COMMUNITY UNIT PLAN SPECIAL PERMIT #1753B

Subject: Vavrina Meadows 1st Addition Amended CUP

Subject: Vavrina Meadows 1st Addition - CUP/Special Permit, Use Permit & Preliminary Plat

SITE PLAN

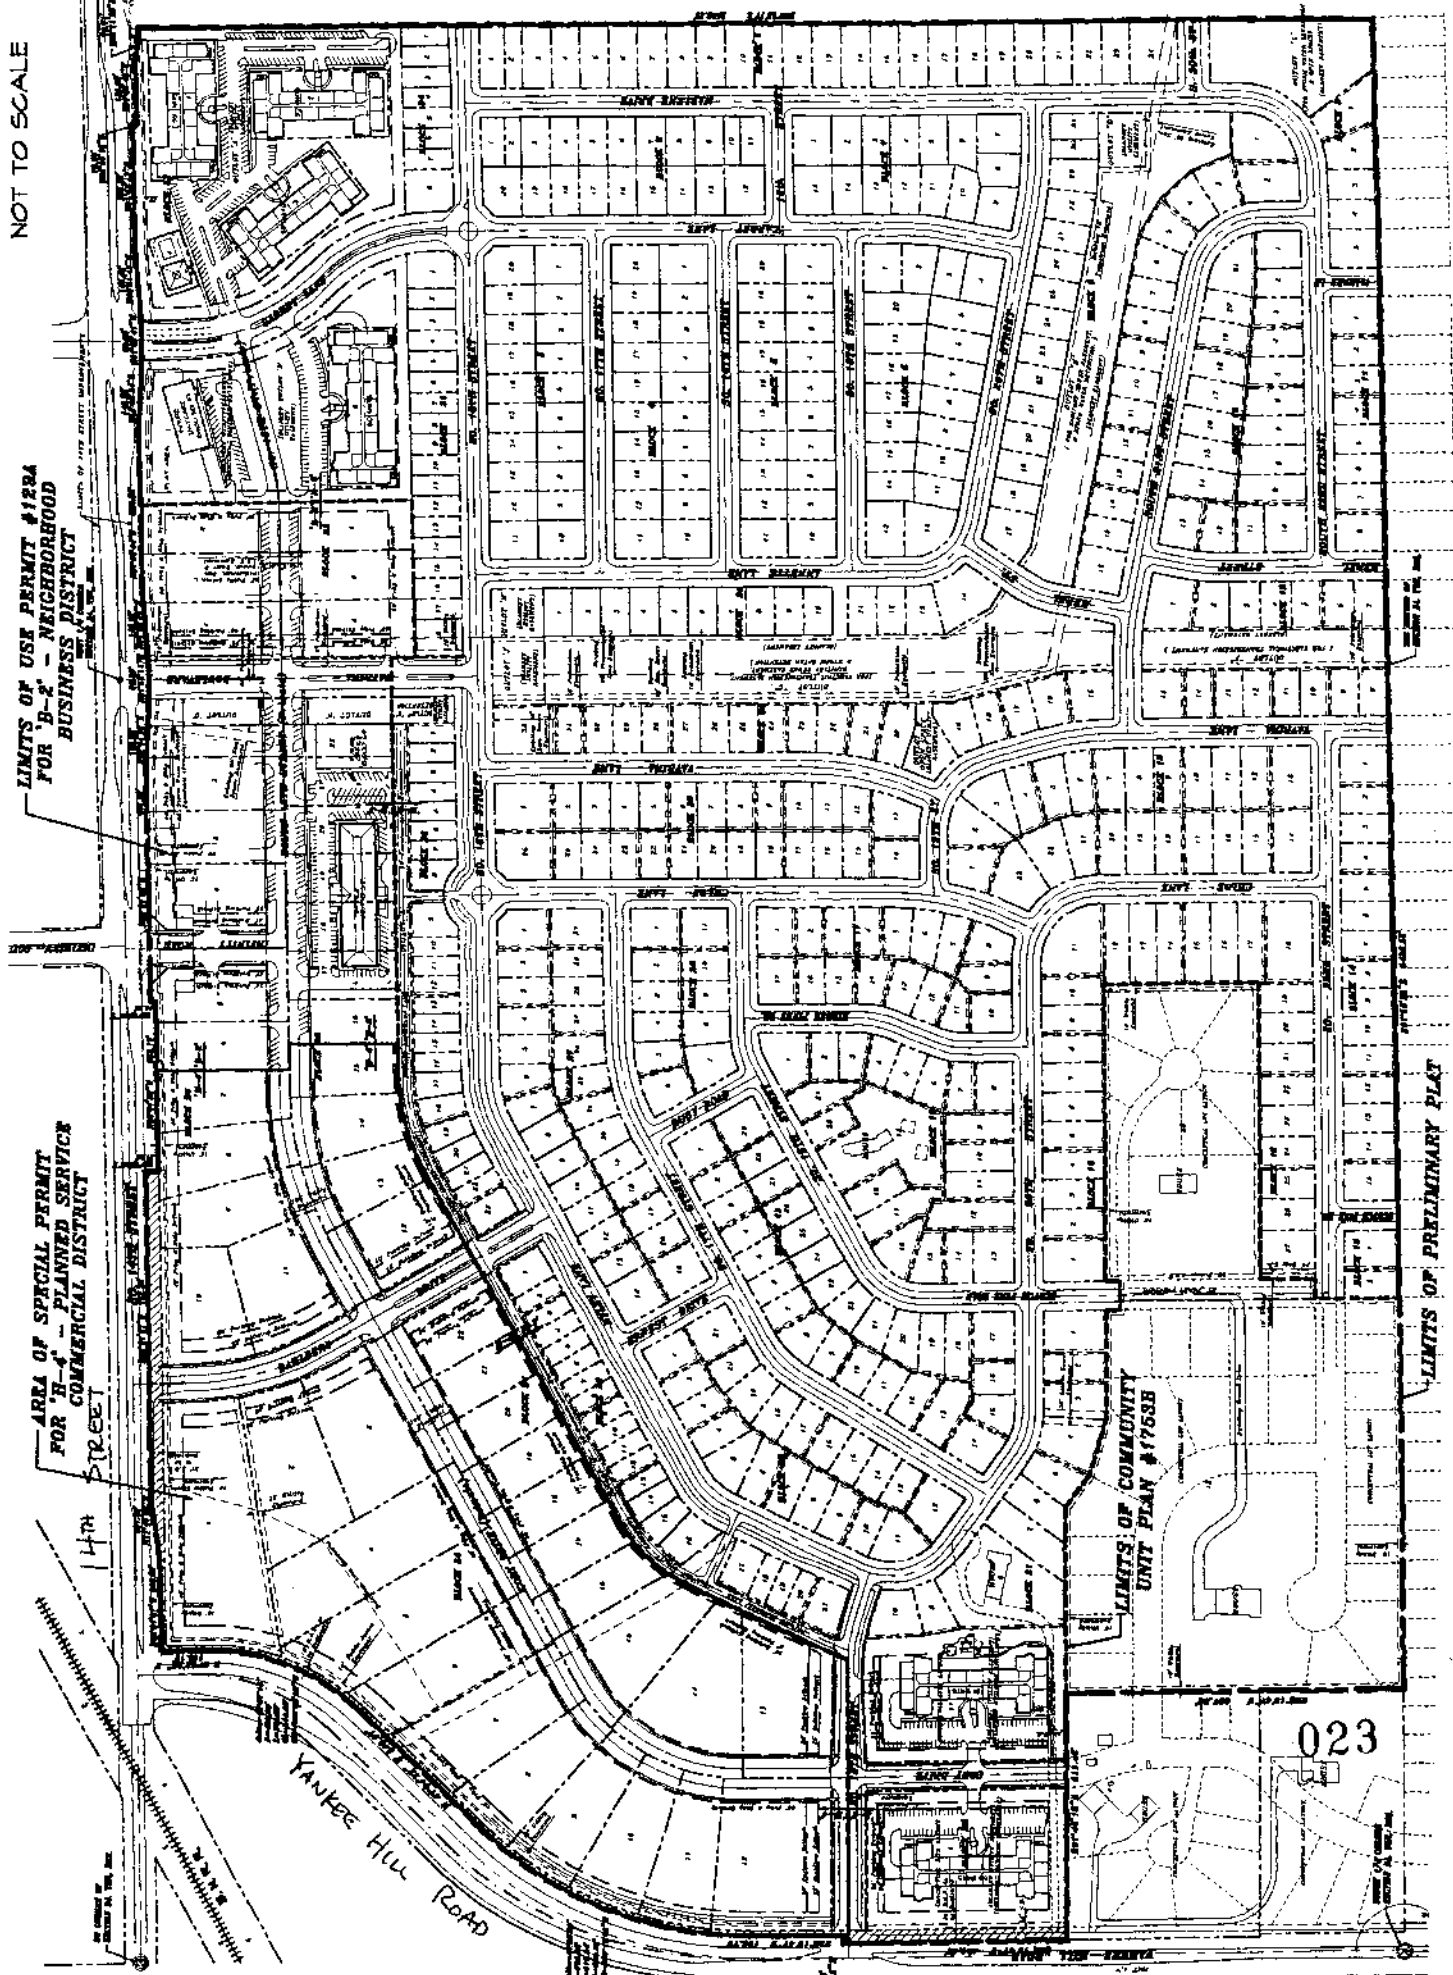
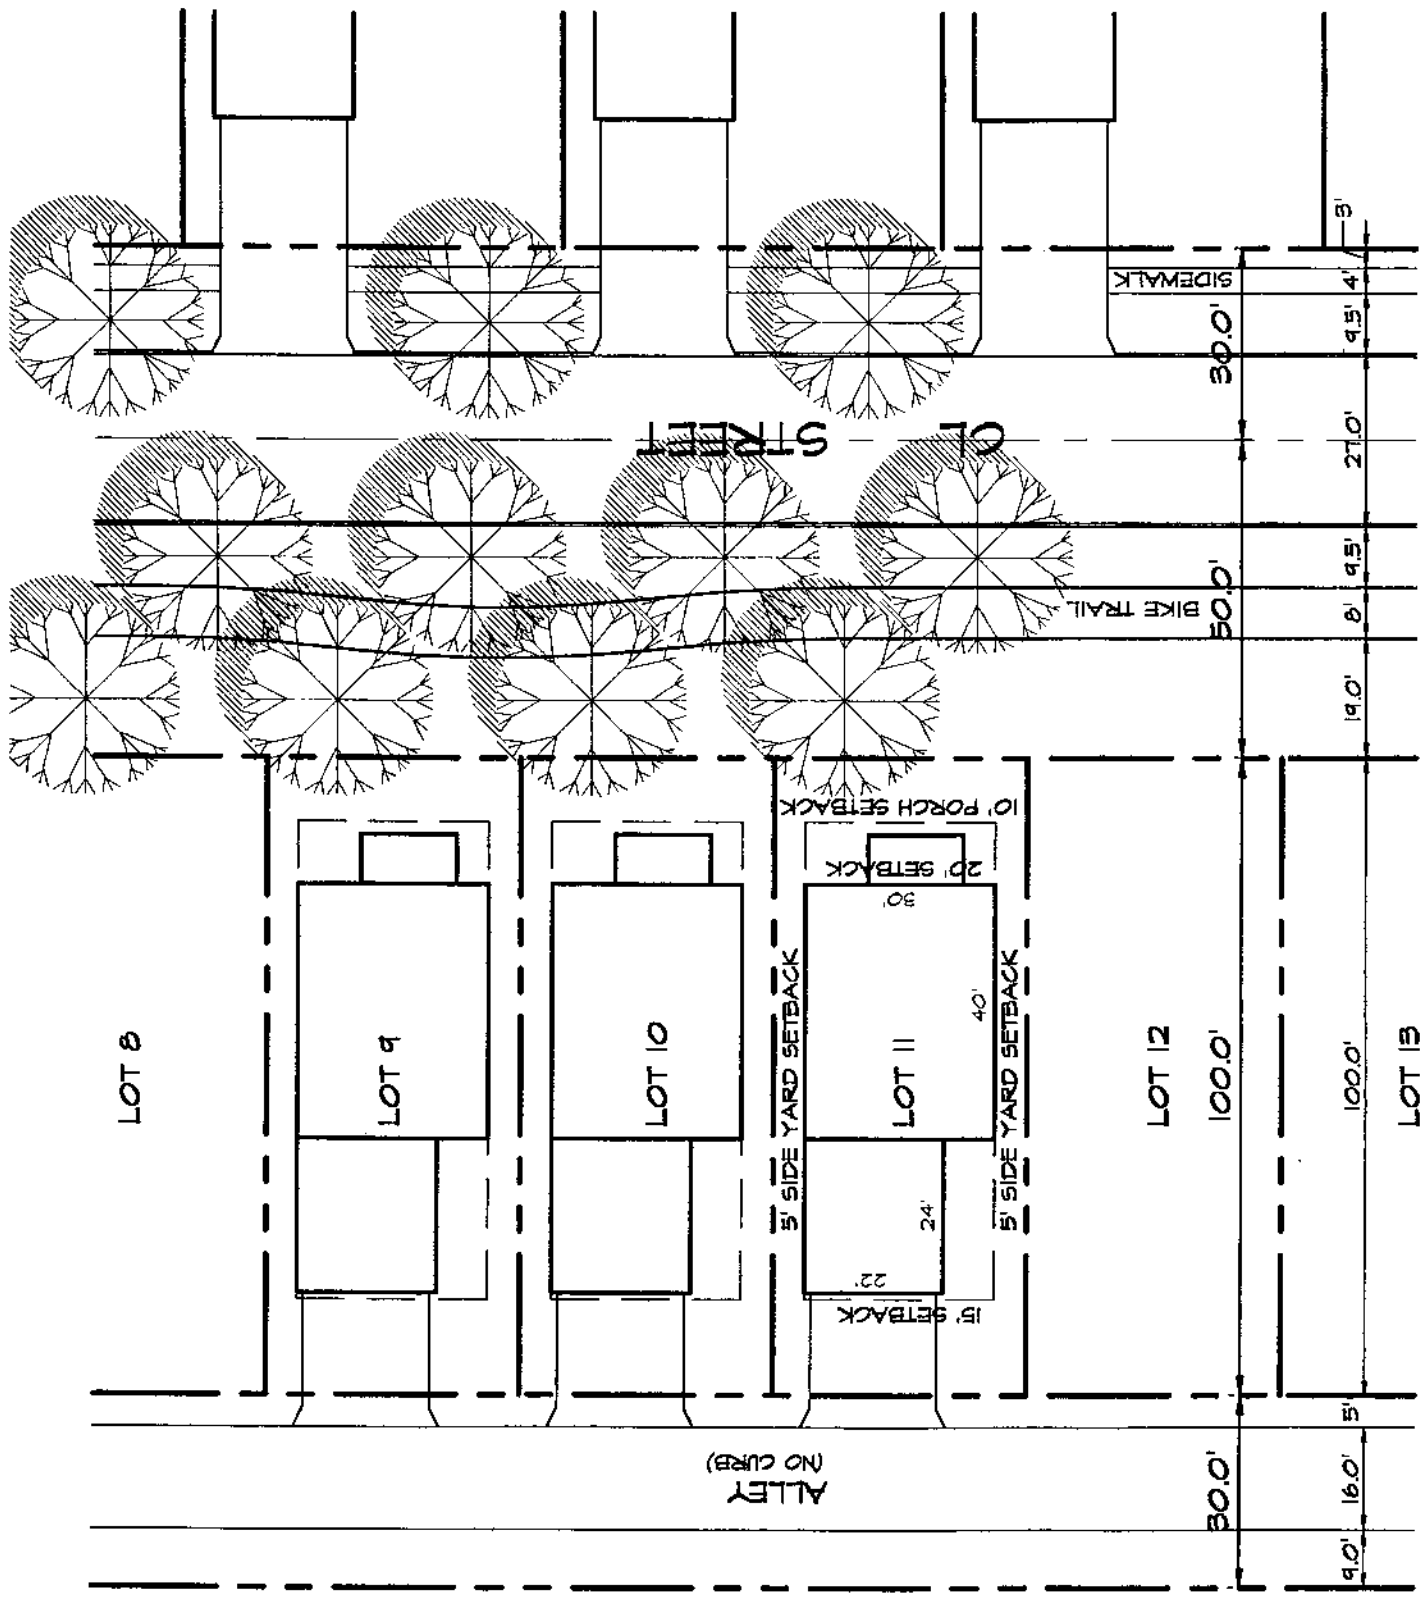
- 1) Traffic circle islands, boulevards, and right-of-way area along trail should be maintained by developer or future homeowners association. "Street trees" between trail and curb will be maintained by the City. Plantings between trail and residences should be maintained by developer or future homeowners association.

- 2) Trail location at Western end of Vavrina Boulevard needs to be a minimum of 8' from curb for snow removal. Any easements for trail along S. 19th St. need to be identified.

- 3) Please submit an outdoor recreation plan for the proposed multi-family residential area in the southeastern area of the site.
- 4) Number of street trees proposed for S. 16th St. (189 Red Sunset Maples) from S. 19th St. to Vavrina Blvd. needs to be revised due to size of lots, proposed 10' wide bike trail, and the eventual mature size of the Red Maple. Staggered planting arrangements can only be done if street trees are located at least 5 feet away from trail and are spaced at 60' on center. Incorporation of evergreen trees on homeowner side of trail may be desirable for aesthetics and screening. Street tree schedule needs to be revised to show correct number based on this spacing requirement.

- 5) Street trees are shown to be planted on center medians for Garret Lane, Dahlberg Dr., and Vavrina Blvd. Traffic Engineering needs to review to determine if there are any traffic sight distance concerns.

- 6) Traffic round-about are shown at S. 16th and Linda Lane and S. 16th and Garret Lane. If these are to be landscaped, the developer must submit plans for review by Parks and Recreation and Traffic Engineering.
